## MEETING MINUTES DAG MEETING #5

### OH PLANNING+DESIGN, ARCHITECTURE

Project Name: Portland Public Schools - Kellogg Middle School Replacement  
Date & Location: 12/21/17 @ Franklin High School  
Prepared by: Tim Ayersman  
Present: DAG: (\*: Present, A: Absent)

The purpose of the meeting is to review the updated floor plans with the Design Advisory Group (DAG).

## Issue: Lockers

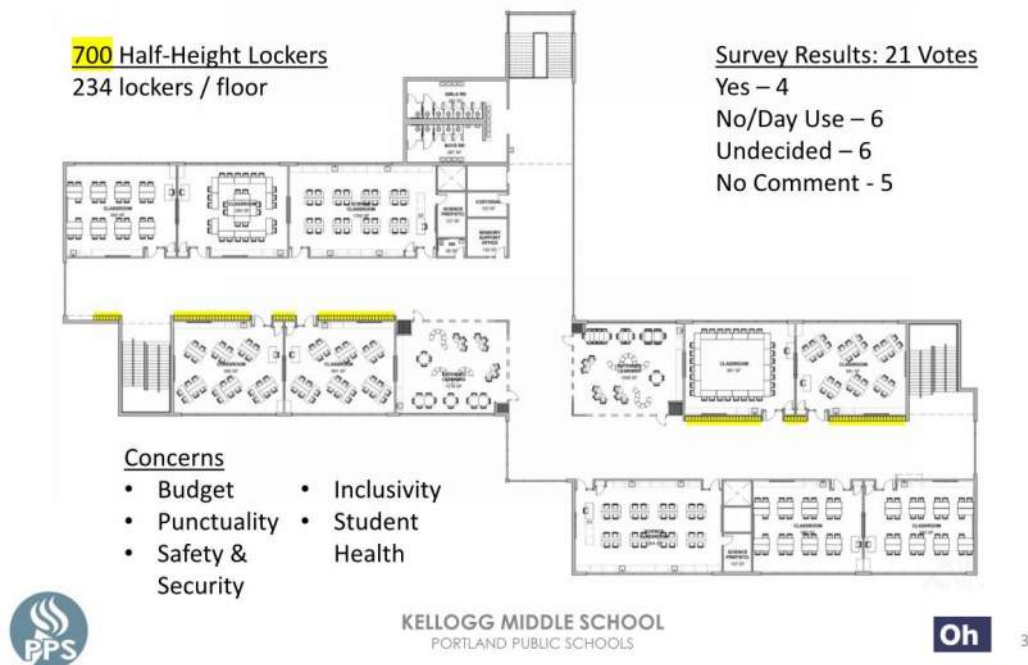
- A. Based on the last DAG meeting the consensus on lockers was split on whether students and teachers preferred them. Per additional meetings with the District the decision to included them in the up-front design was made. With this decision the lockers could still be eliminated in the future if this was desired.

- B. Along one side of the corridor 700 half-height lockers have been located on the 2<sup>nd</sup>, 3<sup>rd</sup>, and 4<sup>th</sup> floor classroom wings. There is additional space to accommodate growth along those walls if the student population goes up to 810.
- C. With the lockers added to the classroom wing the day lockers that were under the stairs have been eliminated.

### Issue: Intensive Learning & SPED Location

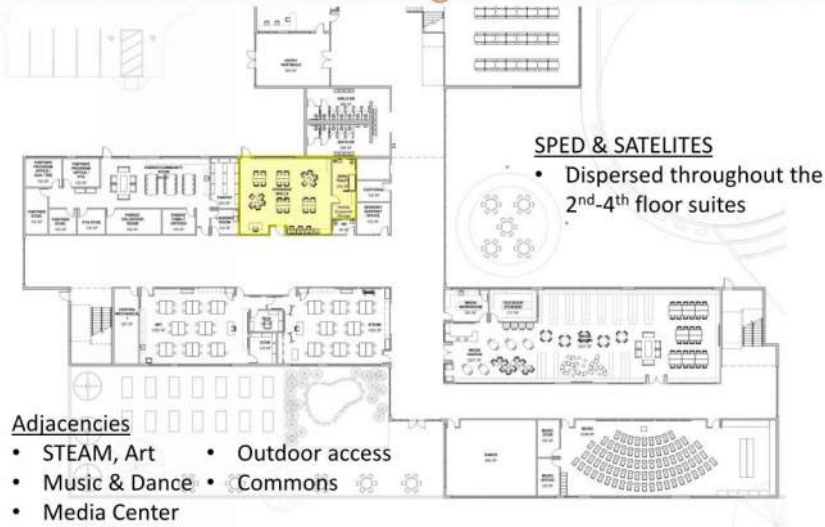
D. The intensive skills classroom is located on the 1<sup>st</sup> floor with an enlarged restroom to accommodate a changing table and required maneuverability for students and teachers. It has an exit to the outside and is centrally located near the STEAM lab, art classroom, media center, and dance/ music programs.

### Issue: Outside Access for Art & Makerspace

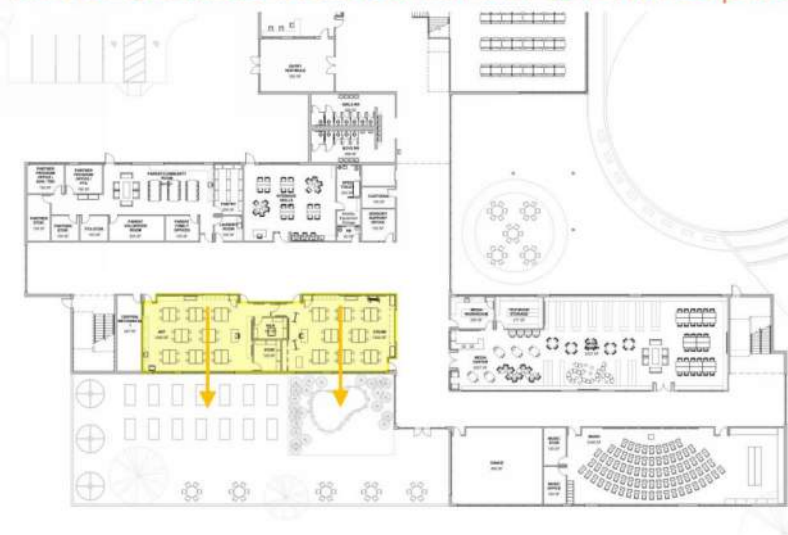
E. The Art and STEAM classrooms have been located on the west wing of the first floor for ideal outdoor access to courtyard.

## Issue: PTA in Community Space

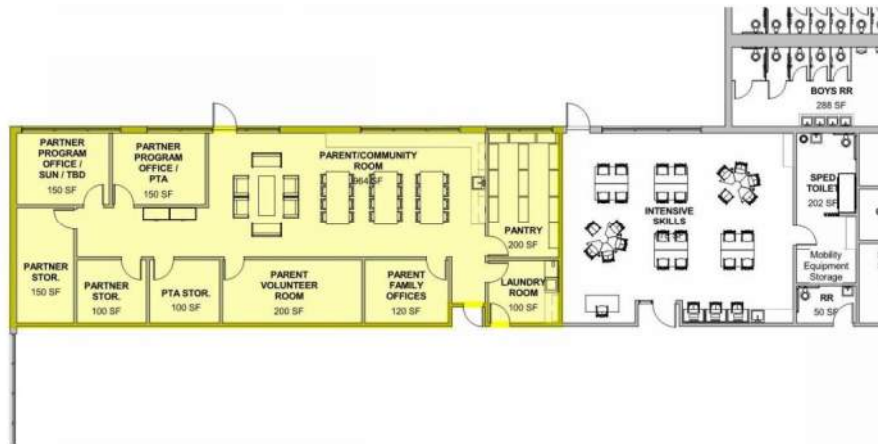
F. The community space now has the offices and storage labeled for PTA, SUN, and potential partners.

I. A DAG member asked if there was a shower or rest-room in this space. The PPS Ed Spec does not include a shower or restroom exclusively for the community partners.

## Issue: Outdoor Learning Environment

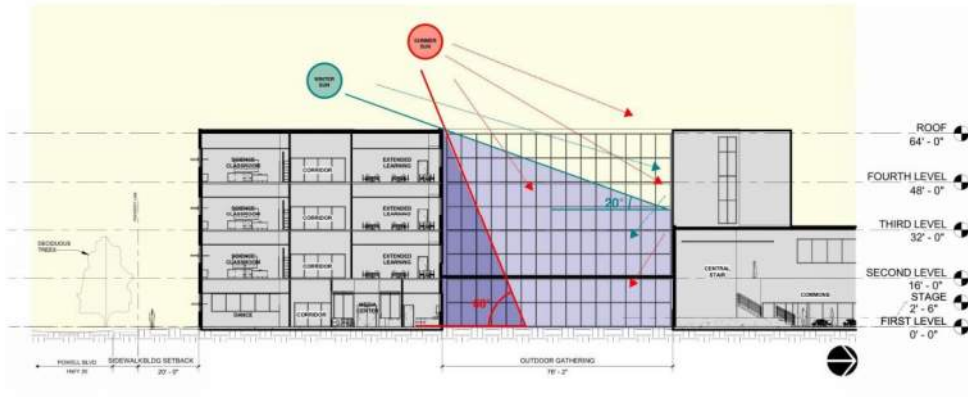
- G. The buildings outdoor learning spaces will receive ambient daylight that are within ideal parameters
  - I. A DAG member asked what the landscape materials will be for the courtyard spaces on Powell and by the Commons. This will be a mix of hard and soft scapes (DF).

## Floor Plans: First Floor

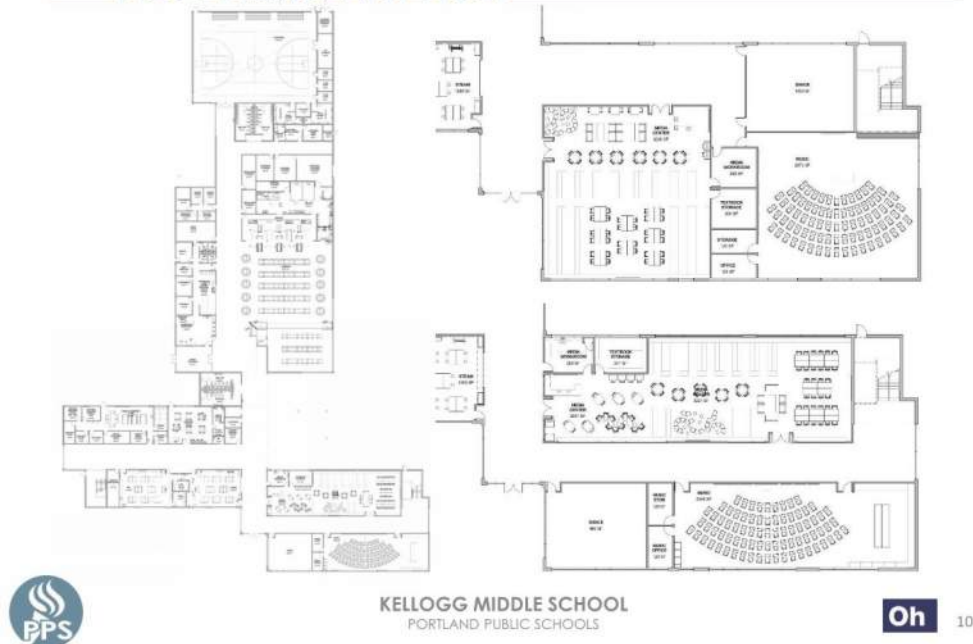
- H. The Dance and Music classrooms have been moved adjacent to library per TOSA recommendations. These instructional spaces are to be integrated with the arts and STEAM classroom wing.

- I. A DAG member asked if there was a concern with the dance no longer having access to locker rooms. The TOSA's did not consider that a concern. They preferred the separation from the PE facilities.

- II. The acoustics with the music across from the media center was brought up. The acoustic engineer is giving recommendations, such as limiting windows, changing partition types in this location, and doors with better STC ratings and seals. We will be going into more defined acoustic conversations at future meetings.

- III. A DAG member noted that having a dedicated dance and music rooms near other arts programs is more inclusive
- I. Two options for the Media Center on the first floor were presented to the DAG members for their comments. Option 'A' has the media center along the north side and the corridor in the center, while option 'B' had the media center along the south side and the corridor on the north side.

- I. A DAG member asked about sound control from band room. In option 'A' two walls and the corridor separate the music from the media center and the office and storage separates it from the dance room. In option 'B' the offices and storage separate the music from the media and only one wall. We are currently reviewing the walls and ceilings with our acoustical engineer. The wall to the music rooms will be designed with sound isolation and the doors will be upgraded for sound isolation. The floor slab above these rooms is being designed for sound isolation as well for both options.

- II. The safety and sound from traffic along Powell for these spaces was brought up by a DAG member. The music space acoustically is better with fewer windows, so the street side will have few and potentially smaller clearstory windows which will be safer and acoustically better. Reviewing this location with our

- engineer it is recommended if we have windows that they are located in a thicker wall with a double set of windows in it for sound.
- III. A DAG member asked what the evacuation procedures were and where the meetup points was to be. OHP+D and PPS will continue to review this as the plan gets developed, at this time the fields will be the area of refuge. (DF)
  - IV. The option “B” that blocks the access to the stairs from the corridor was not preferred by a DAG member, it creates a dead-end wing for band students and isolates them.

## Floor Plans: First Floor-Commons

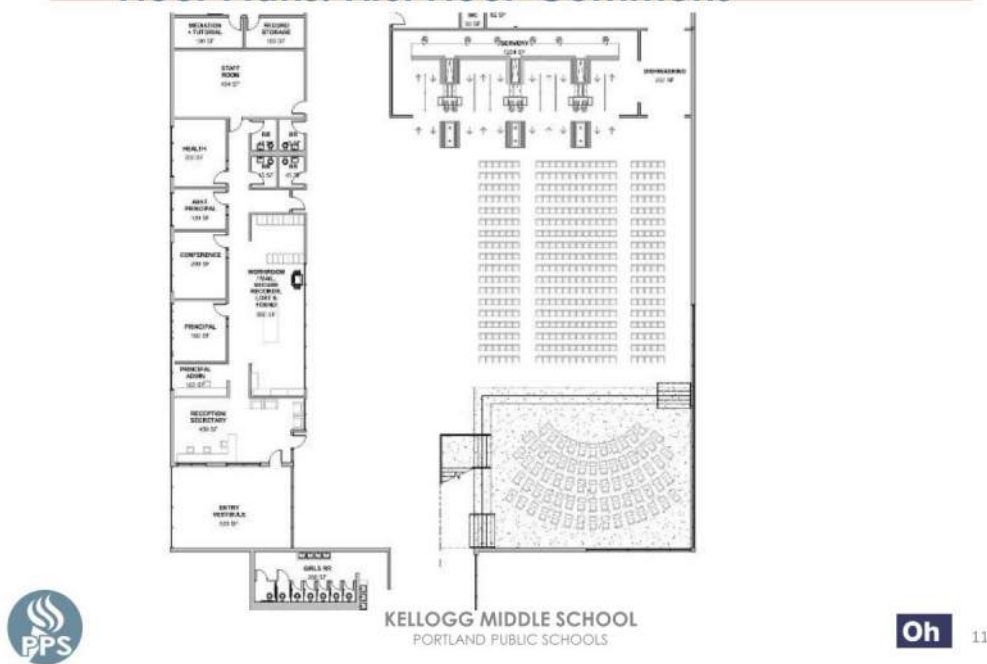
- J. At the commons a stage / platform has been added to the cafeteria, the learning stair has been reduced and the day lockers have been removed now that we are including lockers in the learning suites. The commons can fit all 810 projected students into two lunch periods as it is currently shown.

- I. A DAG member noted that the stage is no longer in the gymnasium now. This is correct, the dance room was being used and designed as the stage before. Now that the dance room has been moved to the classroom wing that removed the stage. This is preferred by TOSA to not have the stage and the dance in the gymnasium. Locating it in the commons creates multi-function to this space without adding square footage to the building that is not in the PPS educational specifications. (DF).

- II. It was asked if the learning stair was completely removed. The learning stair has been reduced to 3 stairs with a performance platform also doubling as a learning platform (DF).

- III. A DAG member asked if the commons could hold an entire assembly. Full assemblies will still be in gym with bleachers. The high school auditorium is typically used for major performances. The middle school educational specification requires the stage located with the cafeteria, at Kellogg we have enlarged the seating capacity of the ed spec cafeteria. It was also noted that the TOSA's did not have a concern with the stage being located in the cafeteria instead of the gymnasium.

- IV. It was noted that there is a benefit in having the performing space closer to main entrance for community use.

- V. Student behavior in a dual use space such as the gym or the commons when used as a performance space is a concern. Lighting, curtains, and furniture arrangement can be used to “switch” psychological perception of the space. Utilizing this space as a “commons” to its full potential, rather than “cafeteria” will aid in defining this space (DF).
- VI. A DAG member asked if the stage will be slanted. For versatility purposes it will not be. (DF).
- VII. A DAG member asked if there was a drama program. The PPS middle school education specifications do not have a drama room / requirements. (DF).
- VIII. It was asked if the sightlines for stage performance work. The sightlines do work with the platform being only a few steps up. We will take a closer look at this while we refine the design.

### Daylighting & Windows

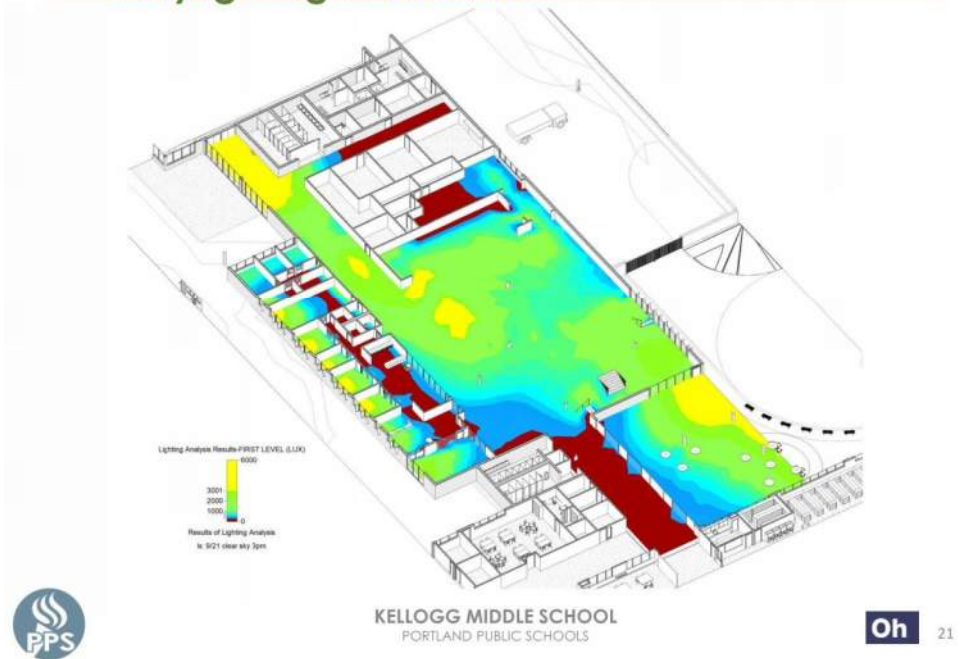
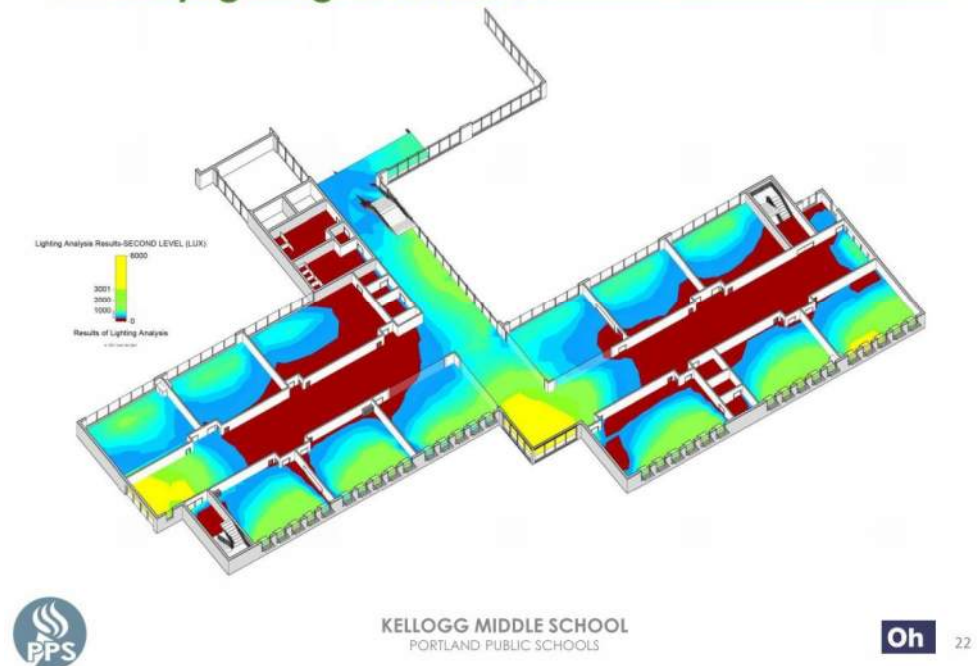
- A. LEED requires 75% daylighting in regularly occupied spaces as a minimum. We have reach this goal, currently at 85%, with our next milestone to reach 90% (DF). Windows sills are currently at 4' for privacy.

## Eco Workshop: PPS Energy

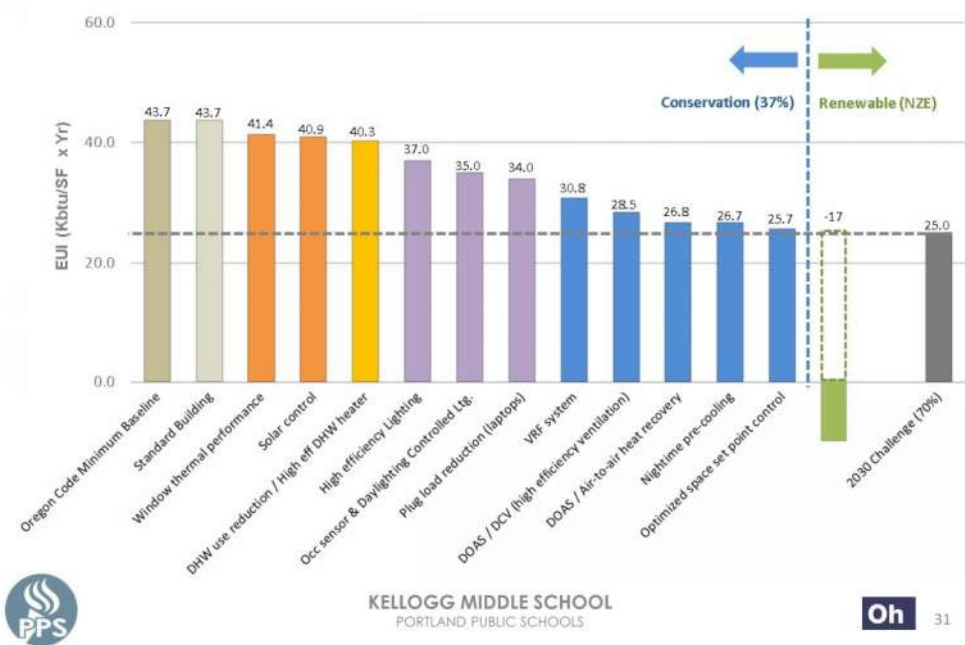
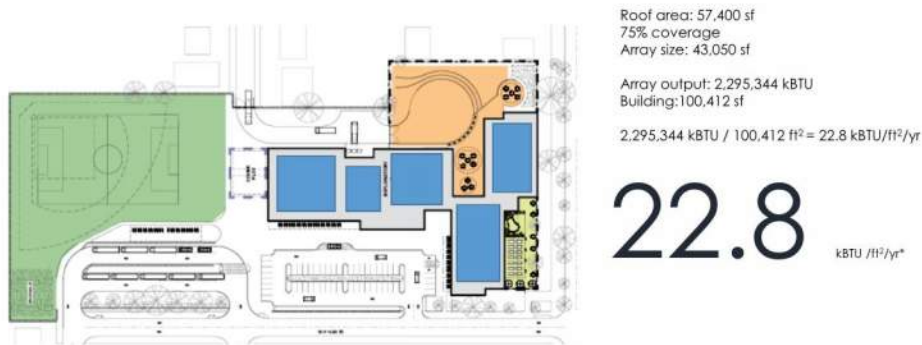
- B. A DAG member asked if the amount of PV estimated account for the embodied energy of the PV. OHP+D will look into this.
- C. To reach net zero for the entire building it would need to be done with renewable energy, solar panels are the most likely option. It was asked what are the costs of creating the actual panels? OHP+D will look into this (DF).

- D. It was asked if other district buildings follow this requirement? There are no net zero buildings in the District. PPS is looking into strategies for future projects (SE). We are discussing the option to consolidate all the state solar requirements for the entire bond at Kellogg (DF). Currently the entire roof will need to be covered in solar panels to reach our sustainability net zero goal.
